RENESAS TECHNICAL UPDATE

Product Category	MPU/MCU	Document No.	TN-RX*-A0229A/E	Rev.	1.00
Title	Errata to User's Manual: Hardware Regarding the I ² C-bus Interface (RIIC)		Information Category	Technical Notification	
Applicable Product	RX610 Group	Lot No.	Reference Document	RX610 Group User's Manual: Hardware Rev.1.20 (R01UH0032EJ0120)	
		All

This document describes corrections to the "I²C Bus Interface (RIIC)" chapter in RX610 Group User's Manual: Hardware.

Figure 22.27 Set/Clear Timing of the AASY and DID Flags during Reception of Device-ID Address

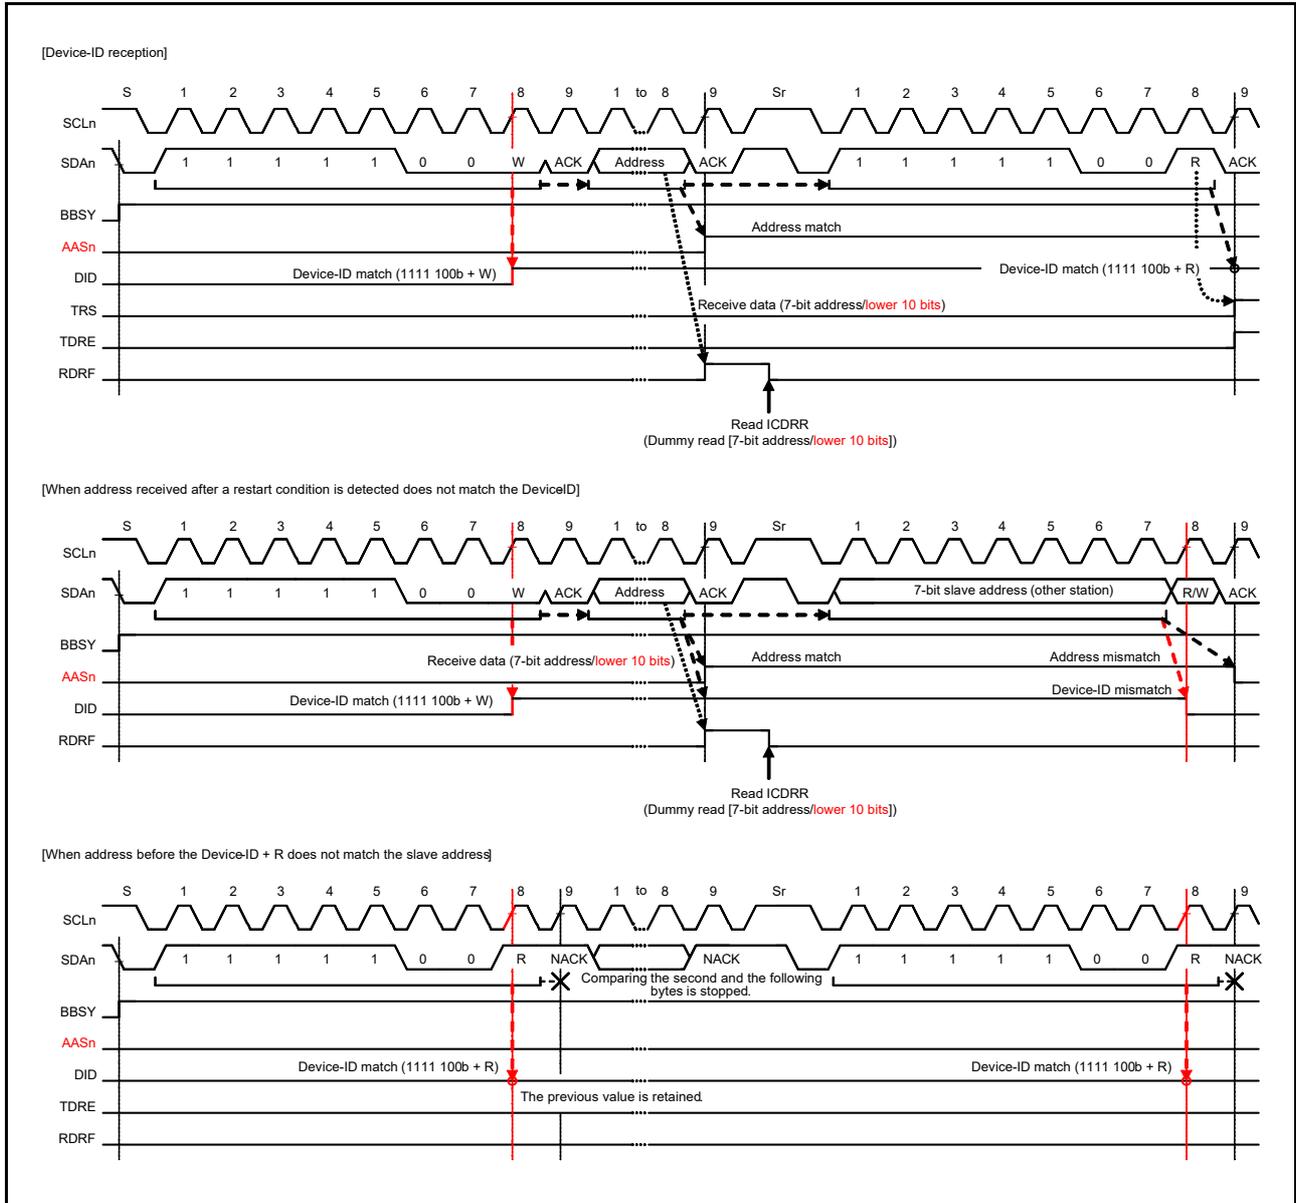
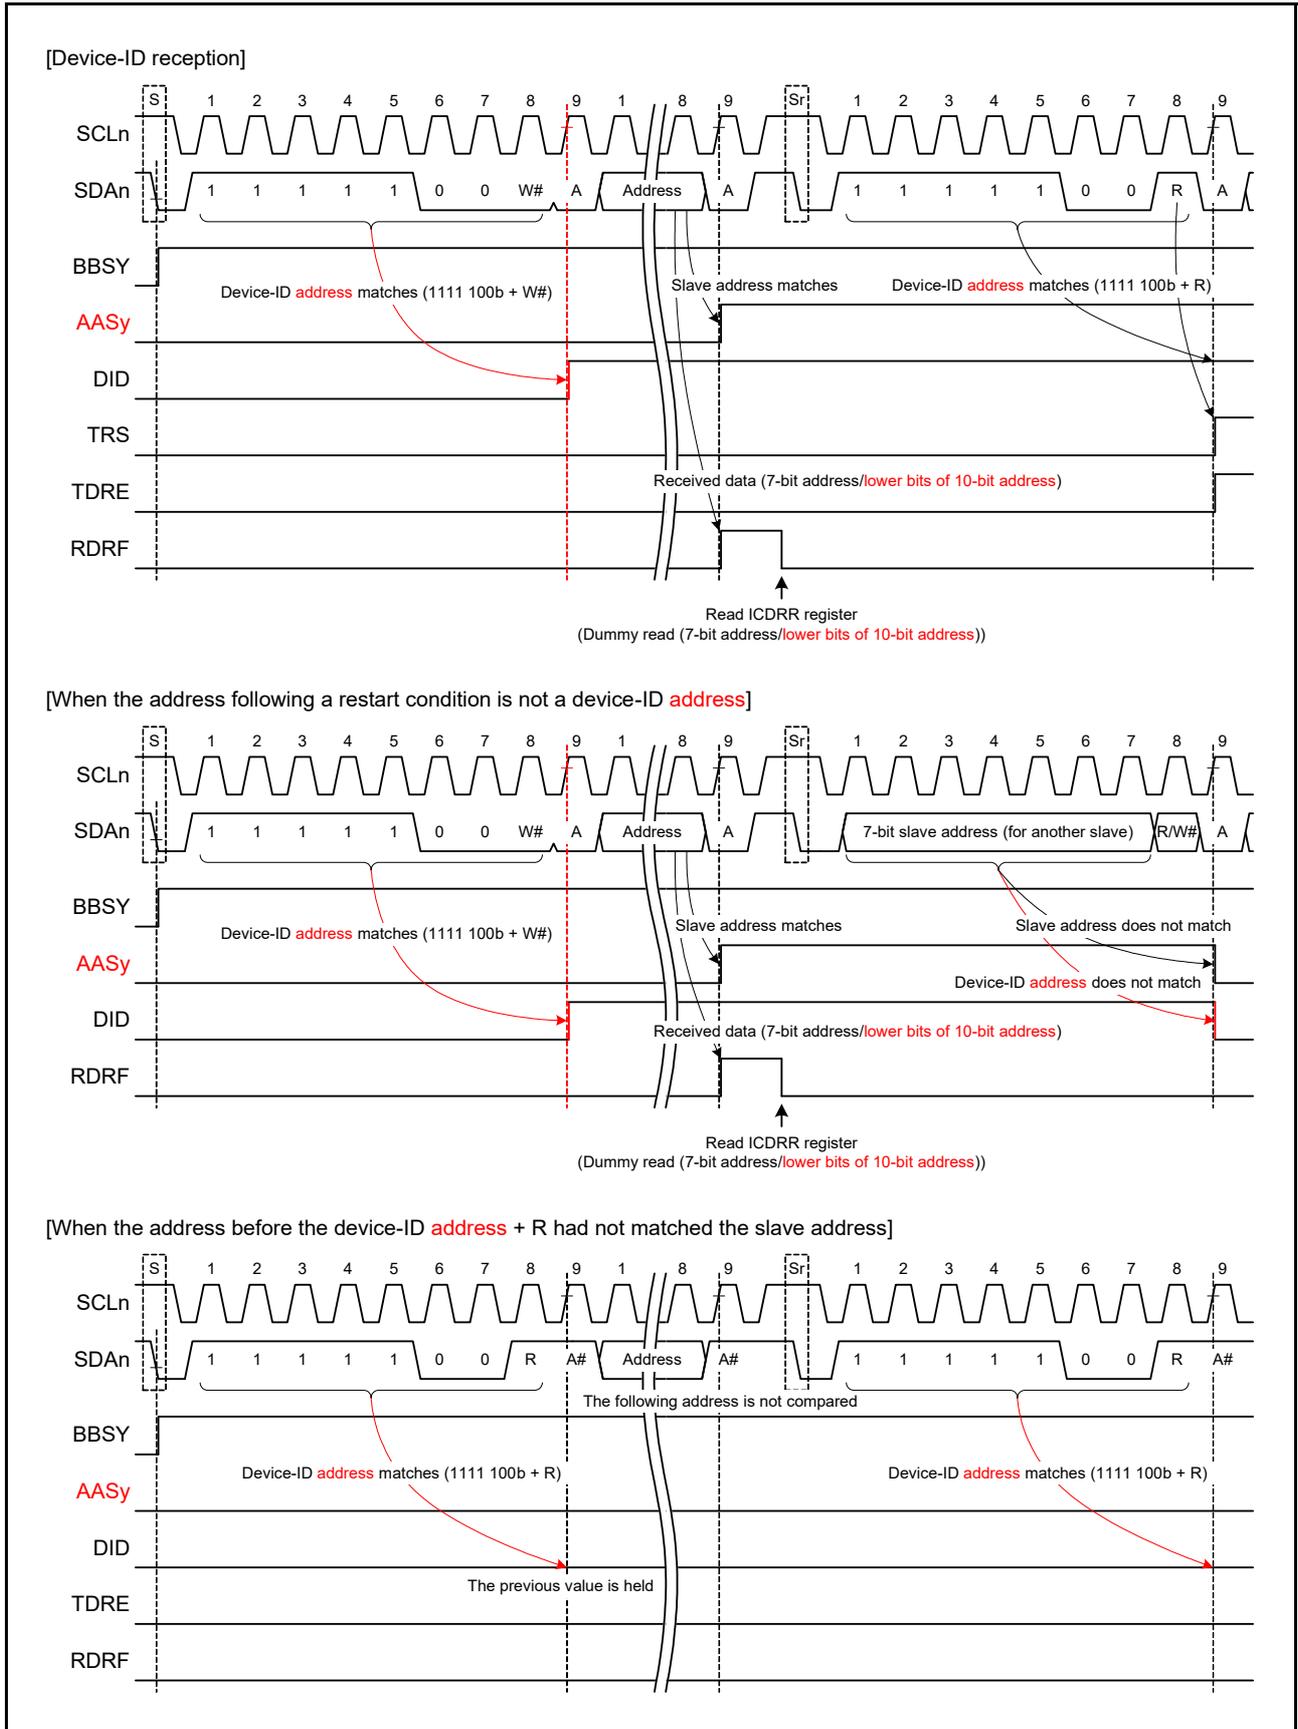
Figure 22.27 in section 22.7.3, Device-ID Address Detection is corrected as follows.

Figure 22.30 Suspension of Data Transmission When NACK is Received (NACK = 1)

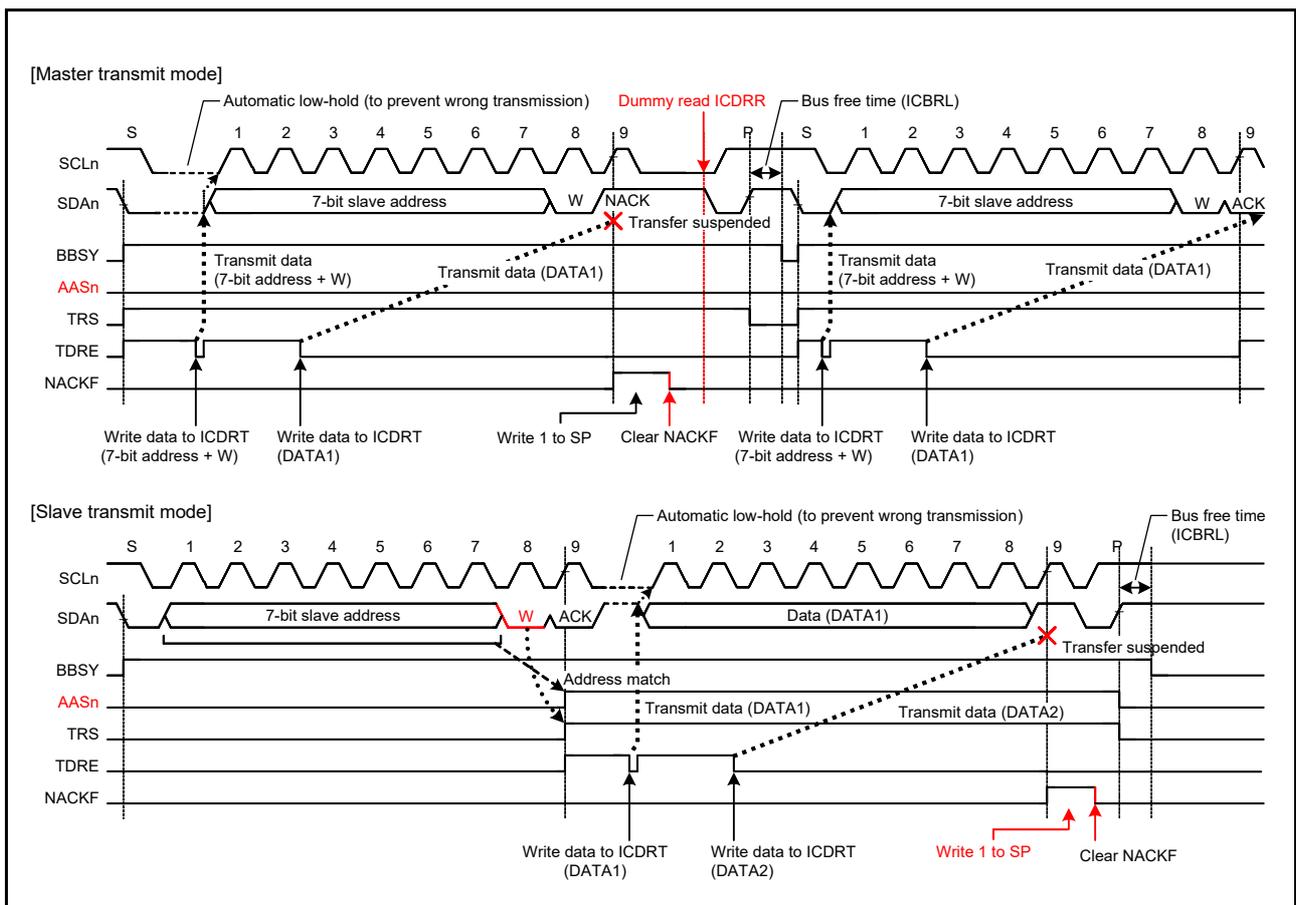
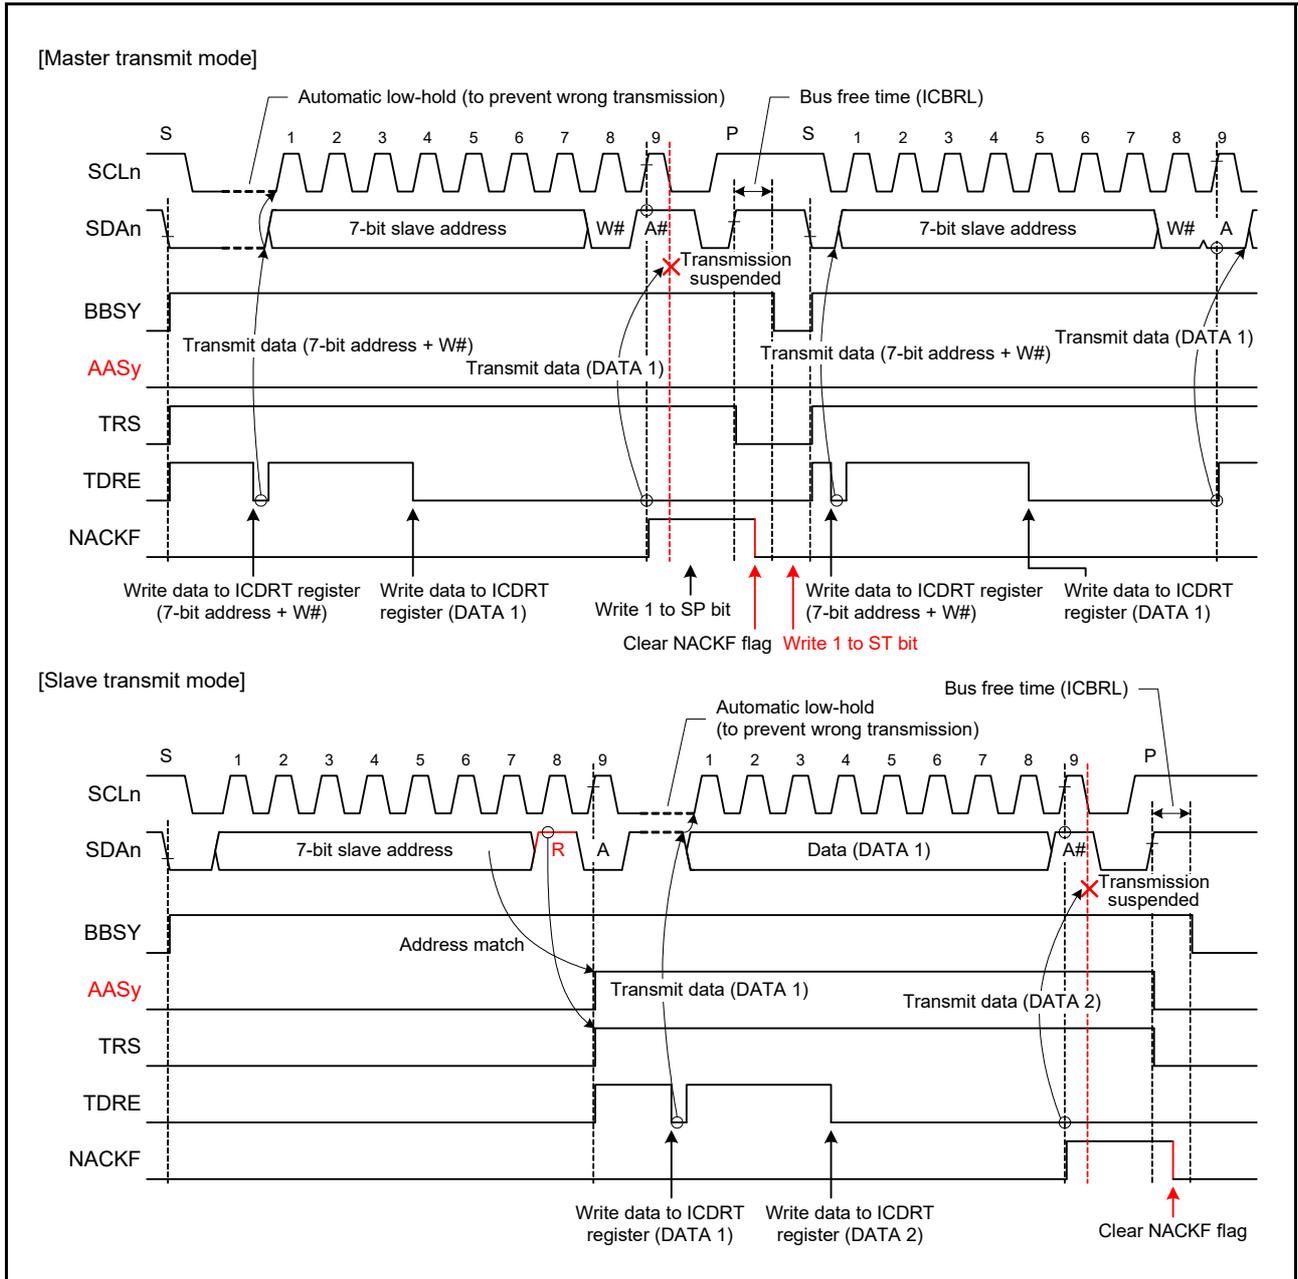
Figure 22.30 in section 22.8.2, NACK Reception Transfer Suspension Function is corrected as follows.

Figure 22.39 Additional SCL Output Function (CLO Bit)

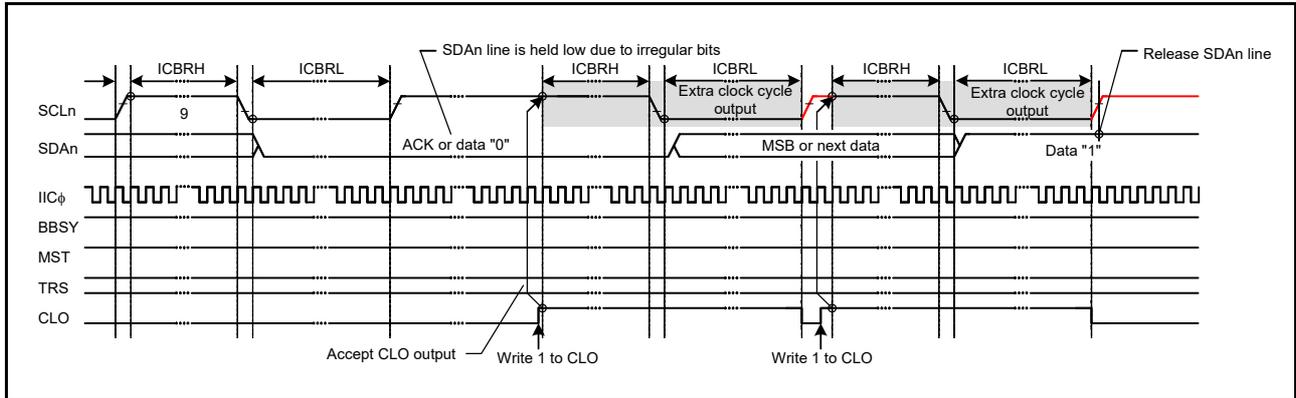
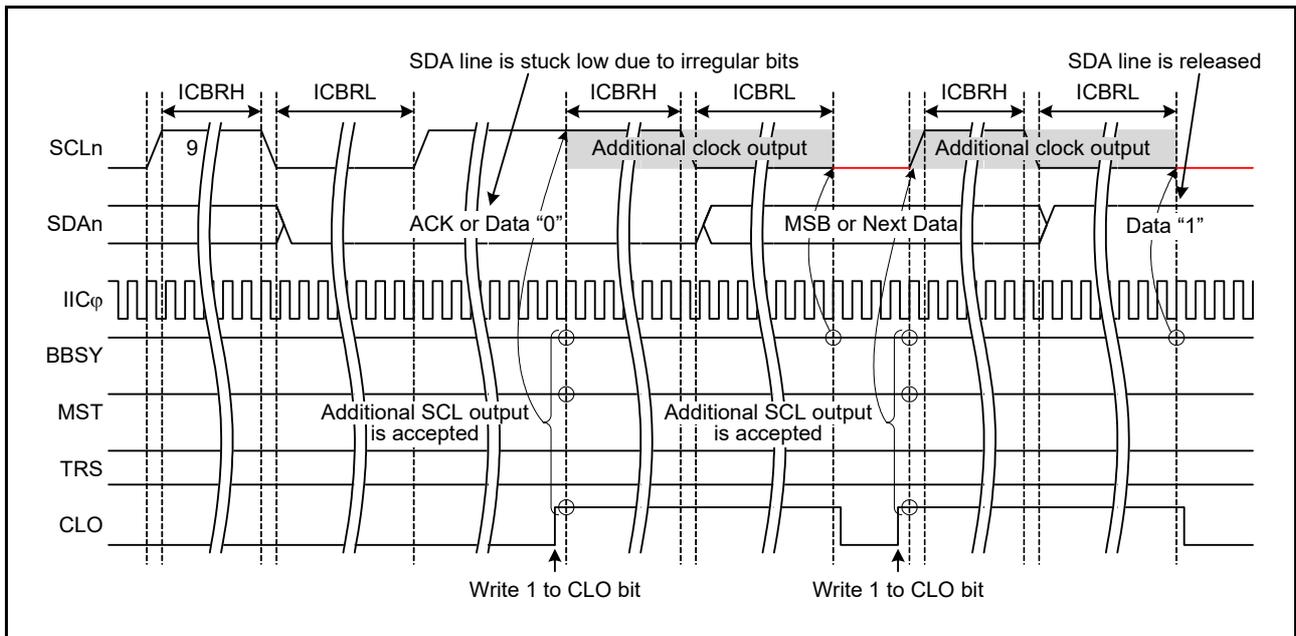
Figure 22.39 in section 22.11.2, Extra SCL Clock Cycle Output Function is corrected as follows.
